MITIGATION PLAN

**Dales Creek Restoration Site
Buncombe County, North Carolina
DMS Project Number 100128
DEQ Contract 7910
USACE AID #: SAW-2019-00834
NCDWR #: 20190864 Version 1**

Re: NCIRT Review and USACE Approval of the NCDMS Dales Creek Mitigation Site /
Buncombe Co./ SAW-2019-00834/ NCDMS Project # 100128

Subject: Dales Creek Restoration Site
Mitigation Plan Review – Response to IRT Comments
French Broad River Basin - 06010105
Buncombe County, North Carolina
DEQ Contract No. #7910
DMS Project #100128
USACE AID #: SAW-2019-00834

**FIGURE 1. PROJECT SITE VICINITY MAP
 DALES CREEK RESTORATION SITE
 BUNCOMBE COUNTY, NC**

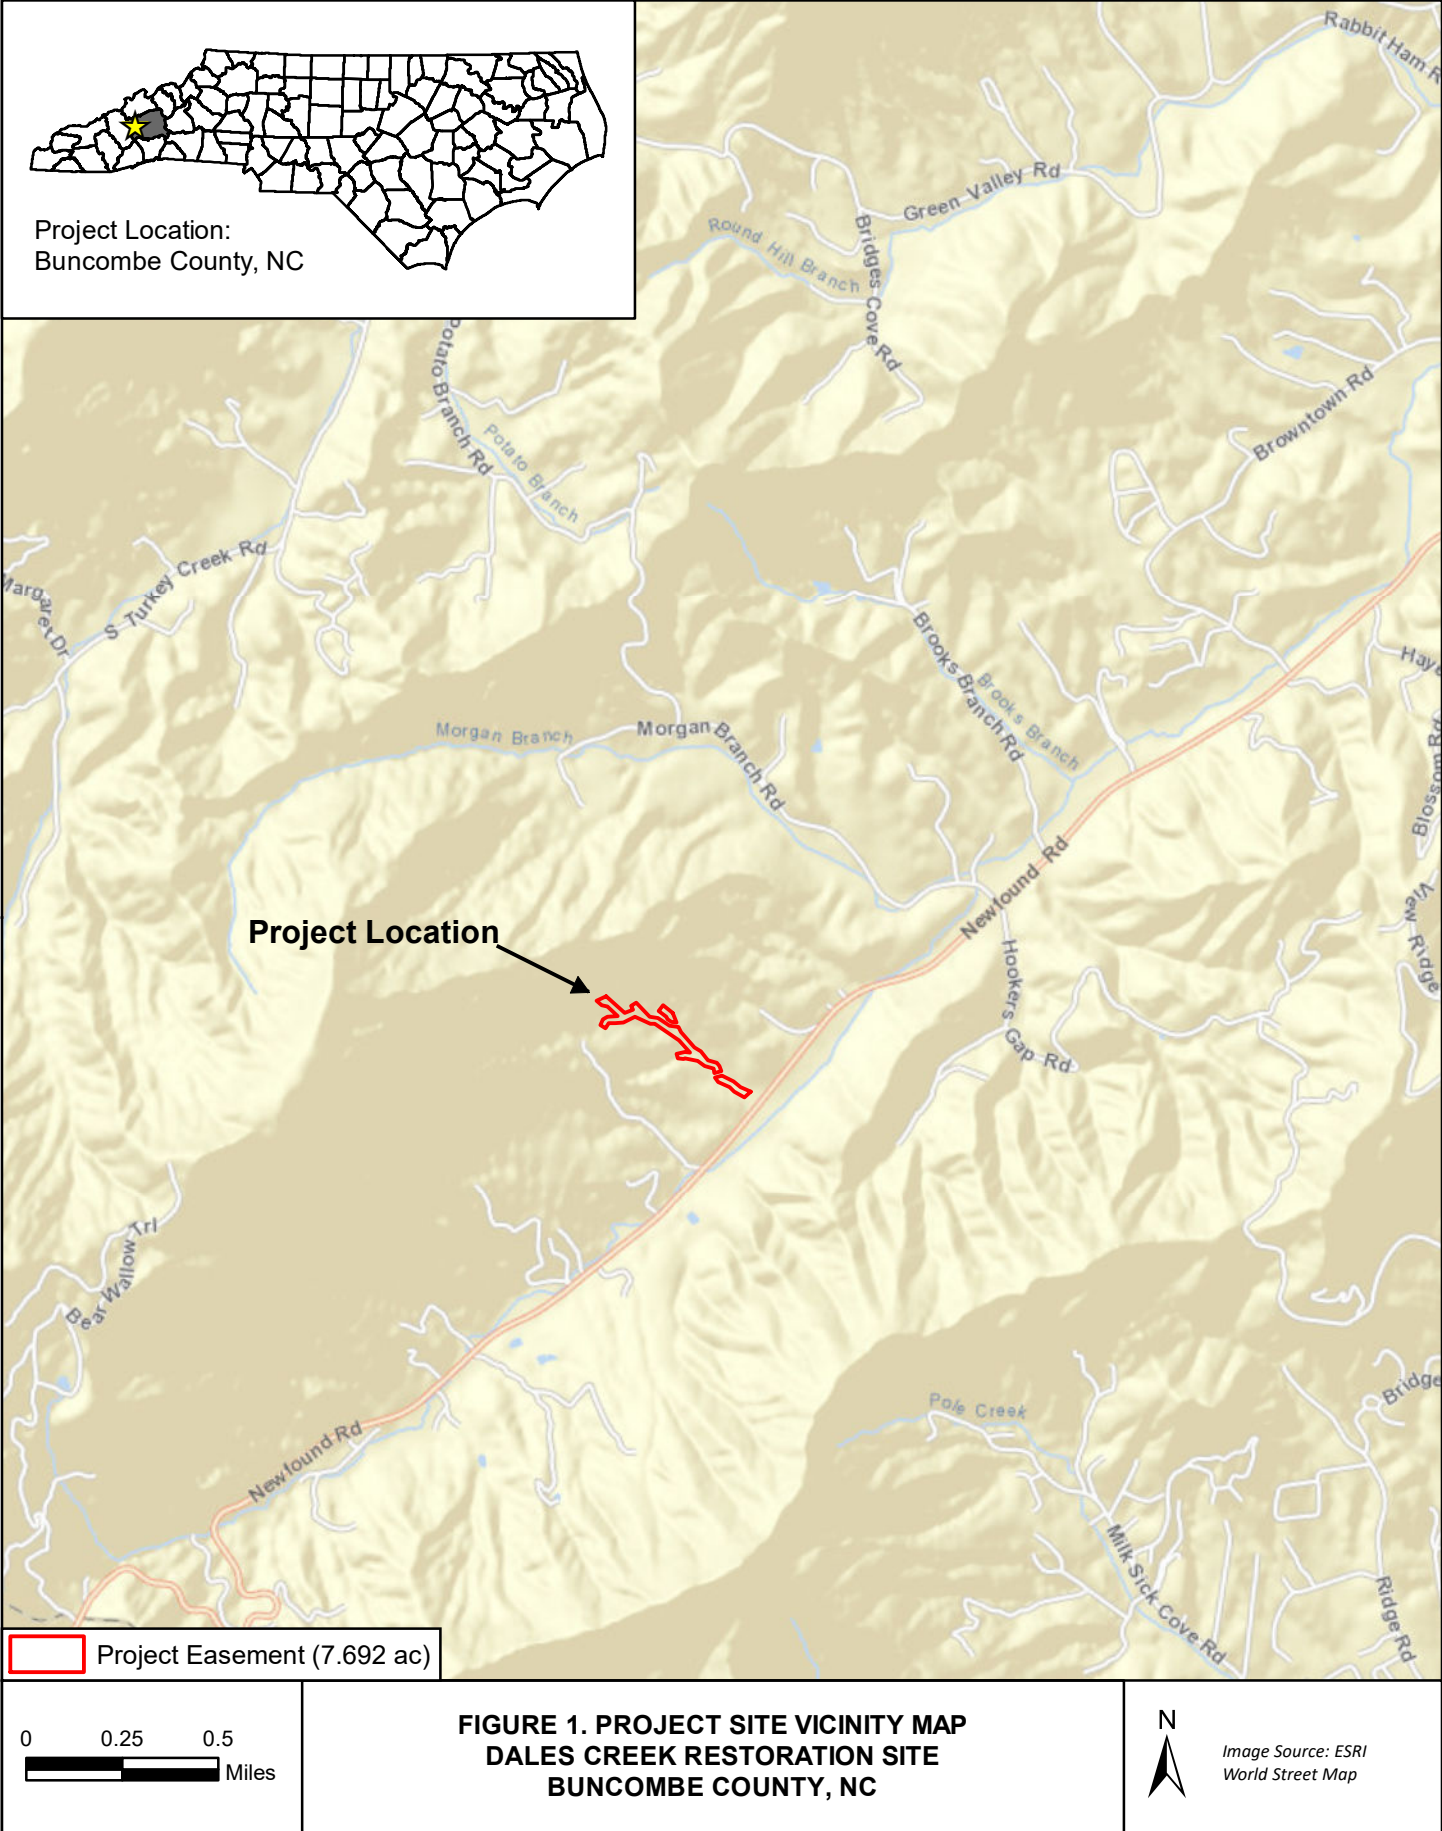
Figure 1 - The proposed easement is identified in the legend but please add text callout identifying the site to the map.

**FIGURE 2. USGS TOPOGRAPHIC MAP
DALES CREEK RESTORATION SITE
BUNCOMBE COUNTY, NC**

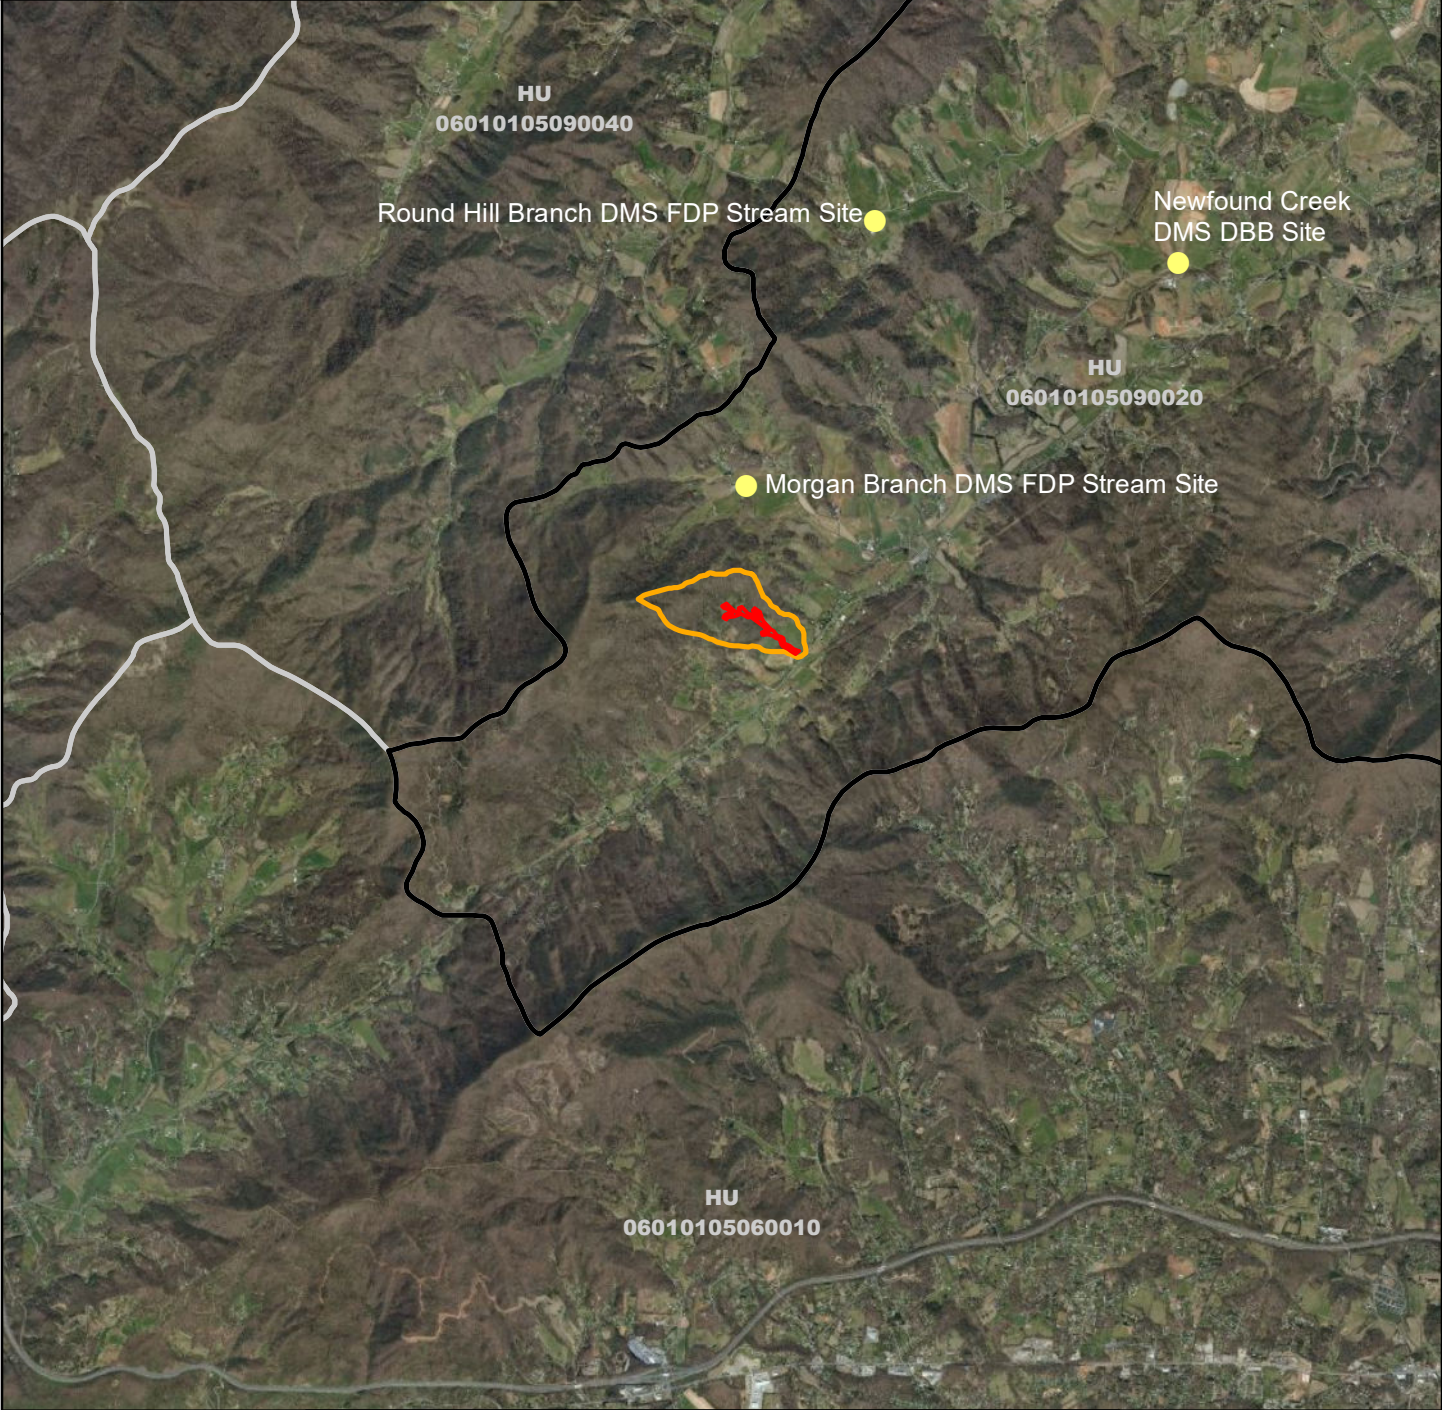
1. DWR appreciates the effort made to reduce the number of crossings, include adjacent wetland features and fence out the ephemeral channel above UT2. All of these things aid with the site’s potential functional uplift.
2. Page 4, Figure 2 – Please show the delineated watersheds for each project tributary.

3. Pages 4-5, Figures 2 & 3 – The watershed area values included in the legends vary from other plan references, please confirm.

The values in Figures 2 and 3 are correct. The watershed size in Section 3.1.2 and Table 4 have been updated to match.

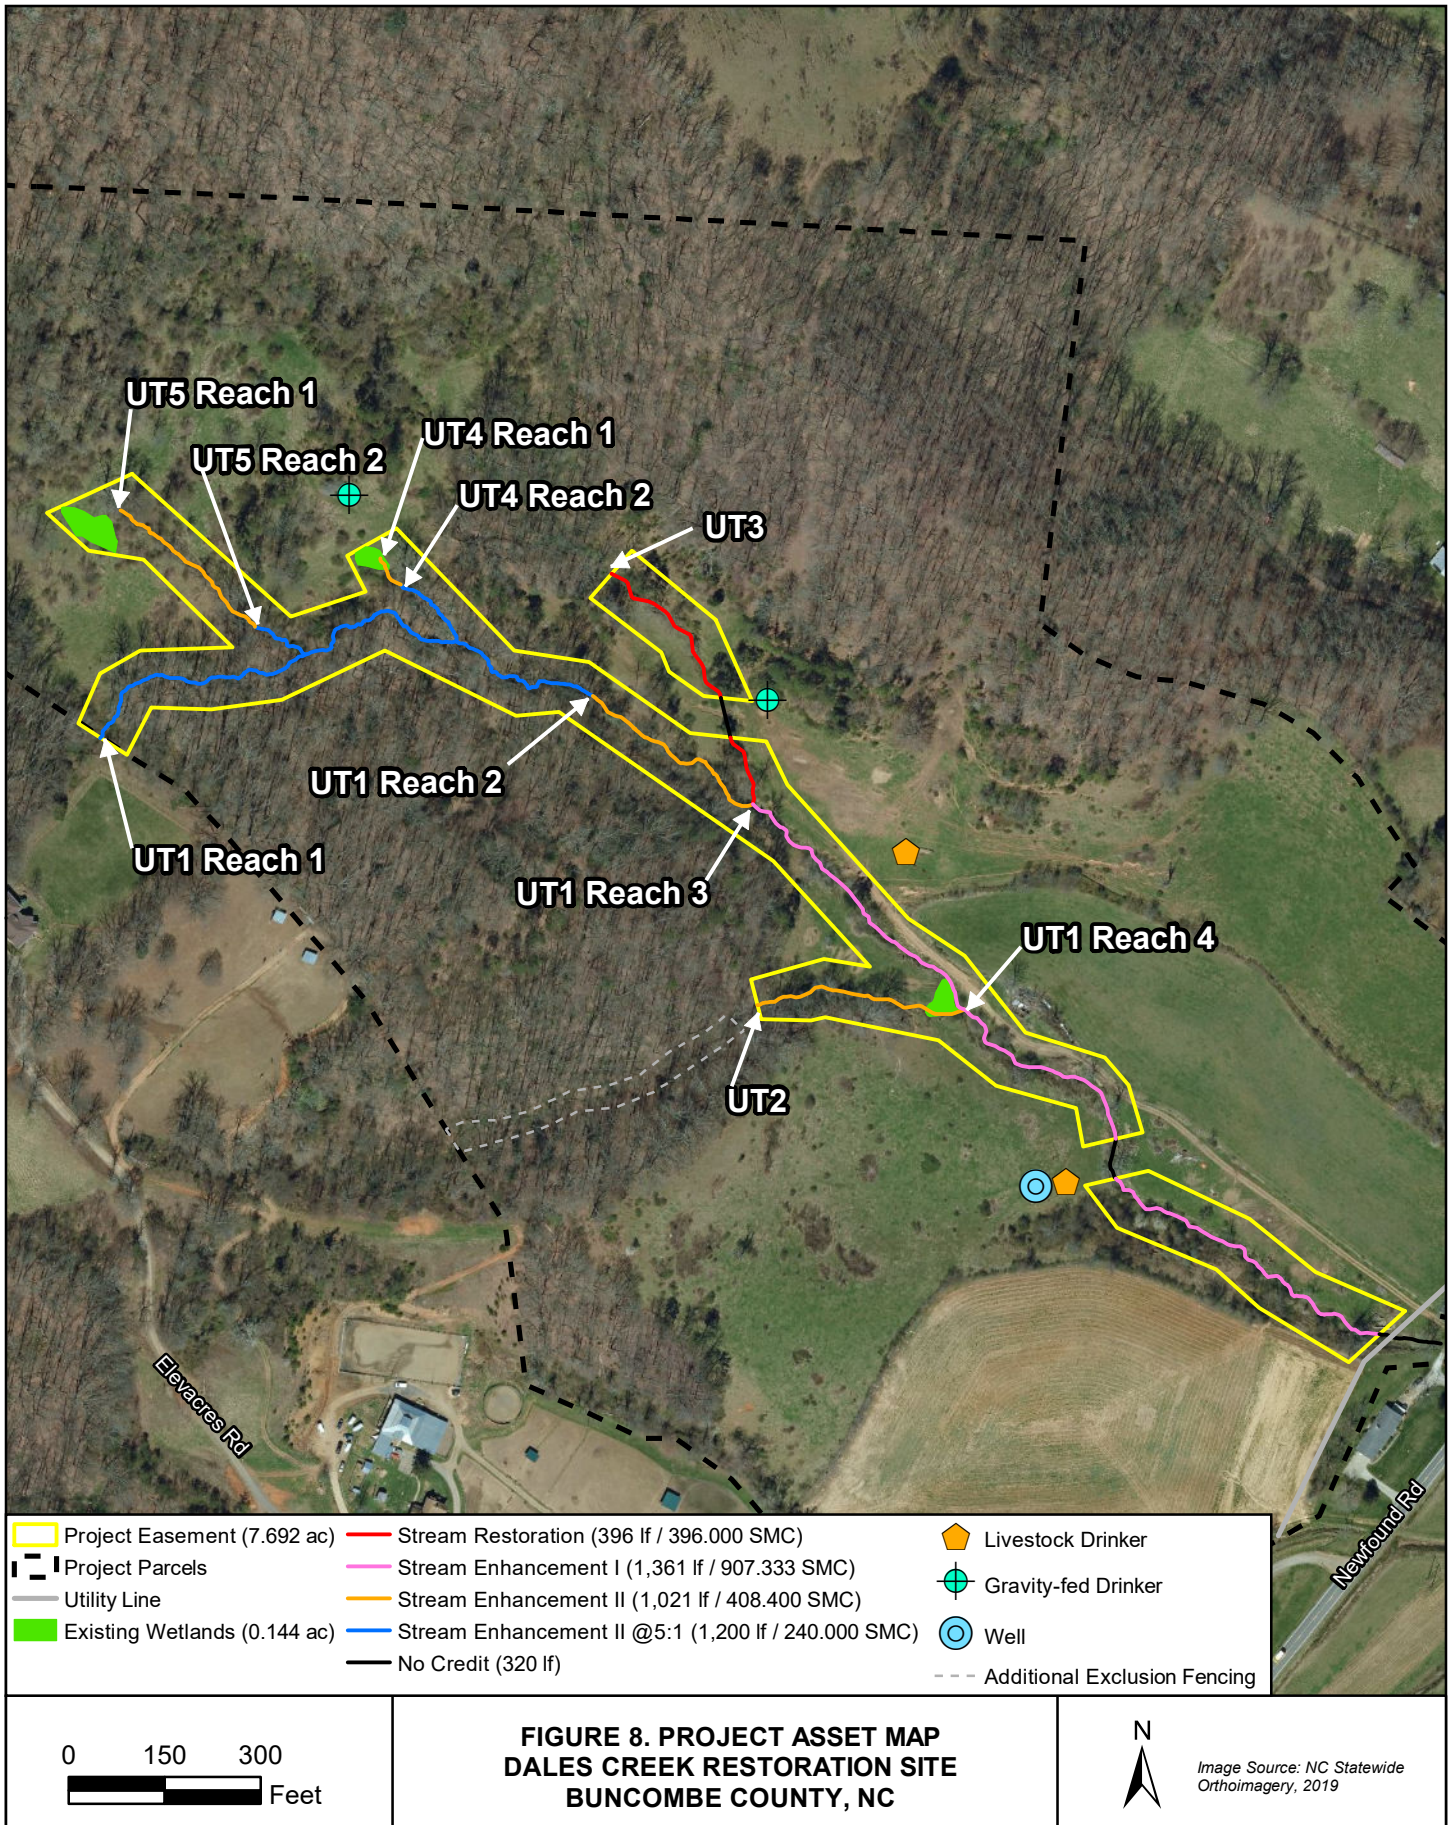
9. Page 22, Figure 8 – Can you please show the additional fencing areas at each of the proposed road crossings. DWR appreciates the extended fencing.
10. Page 28, Section 6.1 – Please include a brief discussion of proposed soil treatment for areas that typically have poor soil characteristics affecting vegetation establishment and growth, including Priority 2 Restoration, Enhancement I new bench cuts, and existing road removal segments within the easement.

8. Page 21, Section 6.5 – DWR appreciates DMS’ questions/comments on the crossings. DWR agrees with DMS’ recommendation that the crossings be internal to the conservation easement.
9. Page 22, Figure 8 – Can you please show the additional fencing areas at each of the proposed road crossings. DWR appreciates the extended fencing.

We have added the locations of farm improvements to Figure 8, and discussed these elements in Section 6.6 on page 21: “Livestock exclusion fencing and gates will be installed to keep all livestock out of the project streams. New fencing locations are shown on the project plan sheets and will be

constructed of woven wire built to NRCS standards. KCI will provide two wells and six livestock drinkers for the cows on the property (see Figure 8) to provide water away from the stream.”

KCI reached an agreement with the landowner that UT2 above the easement could be fenced instead of installing a BMP. The stabilized ford crossing will have a boulder sill that will provide grade control at this transition point. The additional fencing was added to Figure 8.

**FIGURE 10. PROPOSED PLANTING PLAN
DALES CREEK RESTORATION SITE
BUNCOMBE COUNTY, NC**

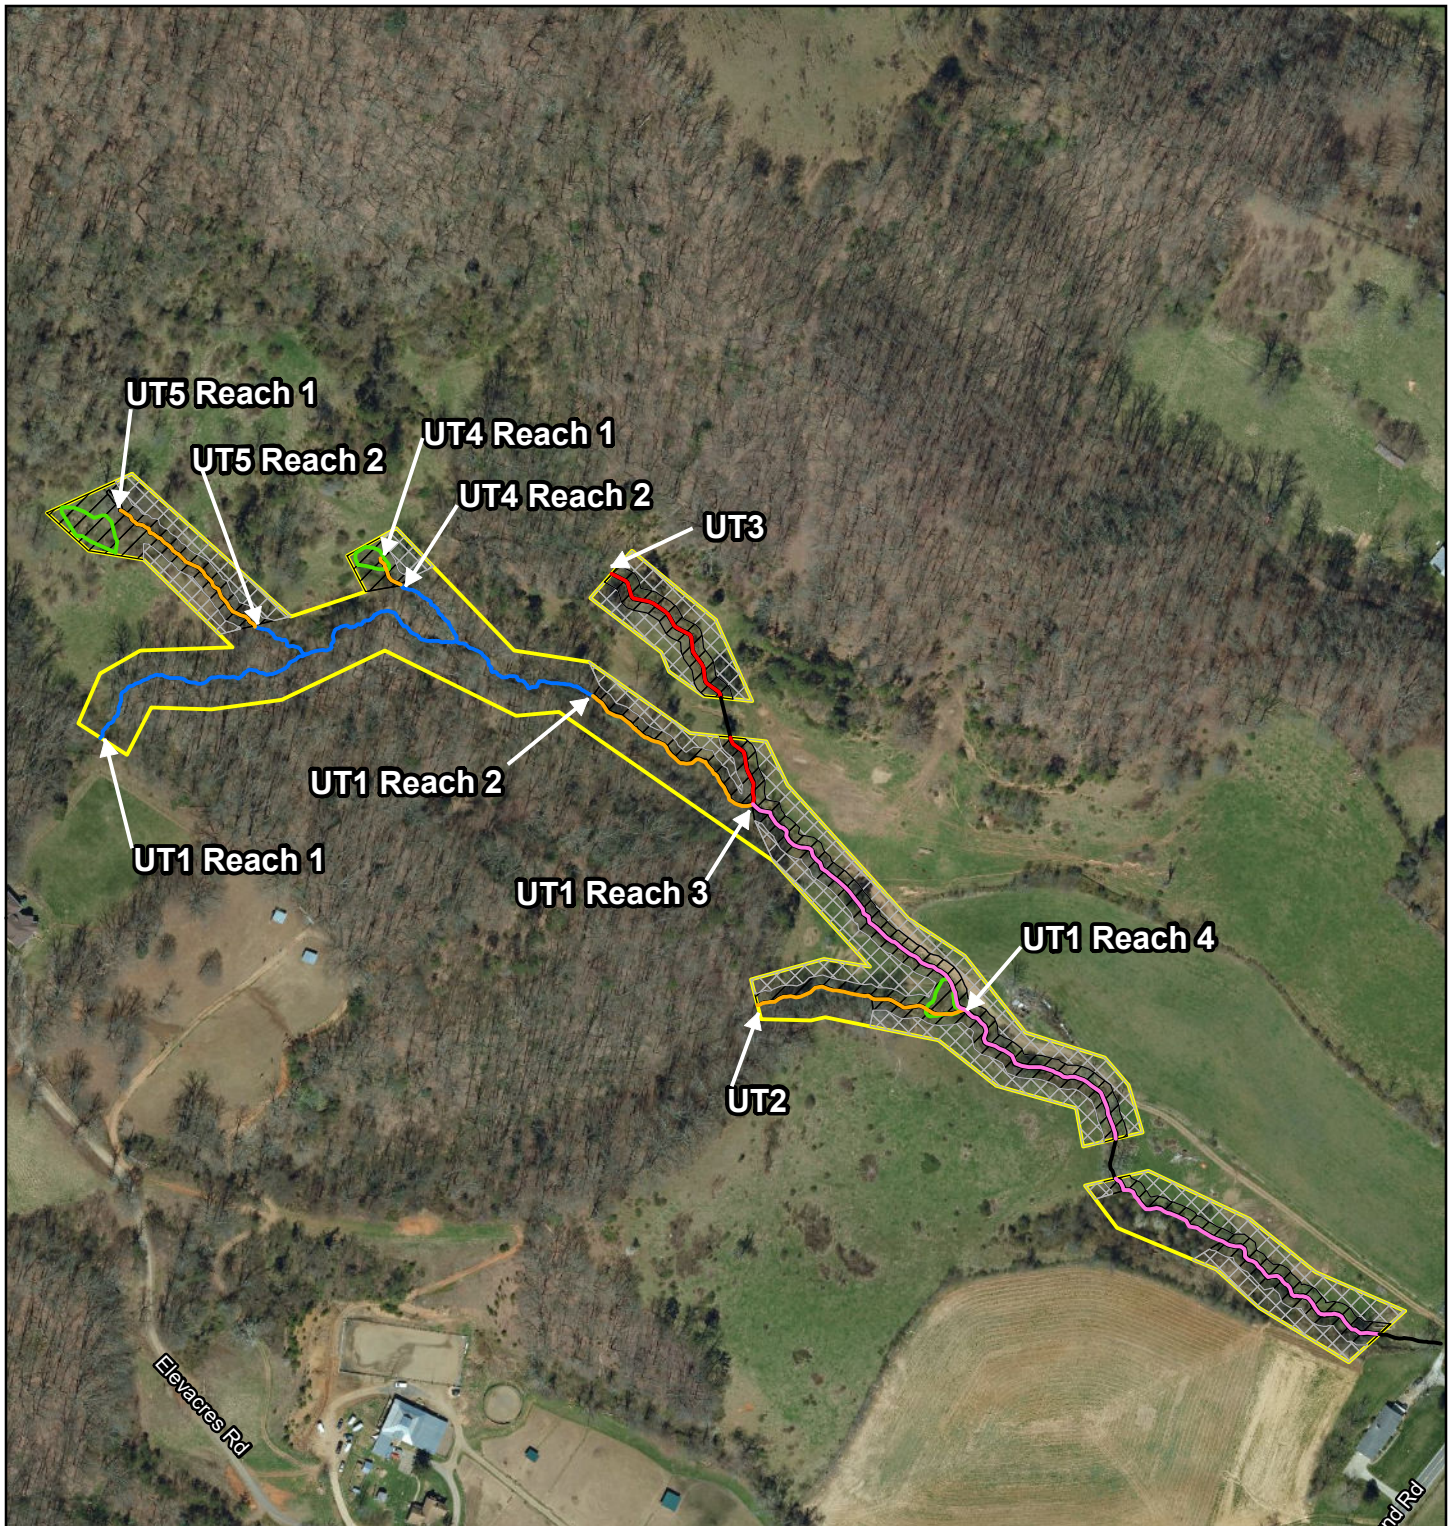
12. Page 29, Figure 10 – For consistency and ease of review, DWR requests the stream restoration line be designated blue.
13. Page 31, Section 7.0 Stream Hydrologic Performance – Please change “within a calendar year” to “within each calendar year”.

12. Page 29, Figure 10 – For consistency and ease of review, DWR requests the stream restoration line be designated blue.

Figure 10 - Are the intermittent document stations for video only? Or something else? The IRT is asking for continuous stage recorders, although it is not a requirement (yet). DMS suggests installing continuous stage recorders to document days of consecutive flow for these intermittent streams.

Additionally, we have added a new figure, “Figure 10. Proposed Planting Plan.”
